**Collingwood South Mixed Use Precinct  
Draft Yarra Planning Scheme Amendment C293yara**

**Yarra Activity Centres Standing Advisory Committee Report 2**

**19 May 2022**

**Map 1: Building and Street Wall Heights**

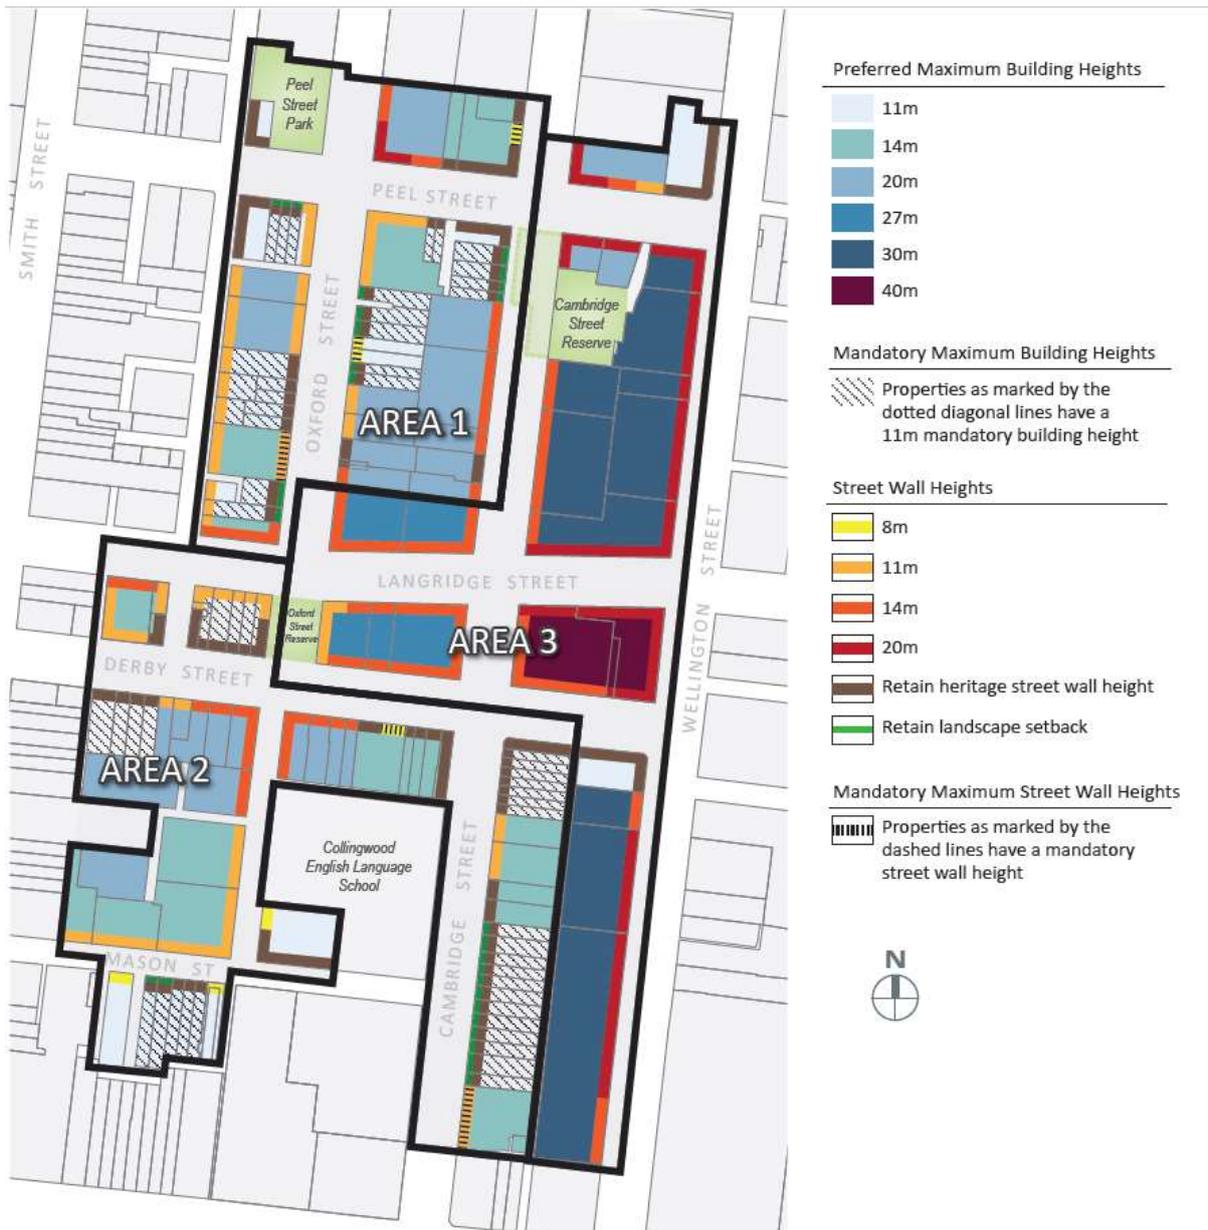
- e) to refer to 'low-rise to mid-rise' in the second design objective
  - f) to change Map 1 to show the preferred maximum street wall height for the land abutting the east side of the Oxford Street Reserve with a street wall height of 11 metres

- g) to show on Map 1:
    - Area 1 and Area 2 combined to form Area A
    - Area 3 renamed Area B.
  - h) to clearly distinguish the upper level setback requirements applying to heritage and non-heritage buildings and to improve the clarity and intent of the provisions

- o) include a range of drafting changes to improve the clarity and intent of some requirements.
  - p) show in Map 1:
    - greater differentiation between colours and consideration of other cartographic tools to improve the map’s legibility
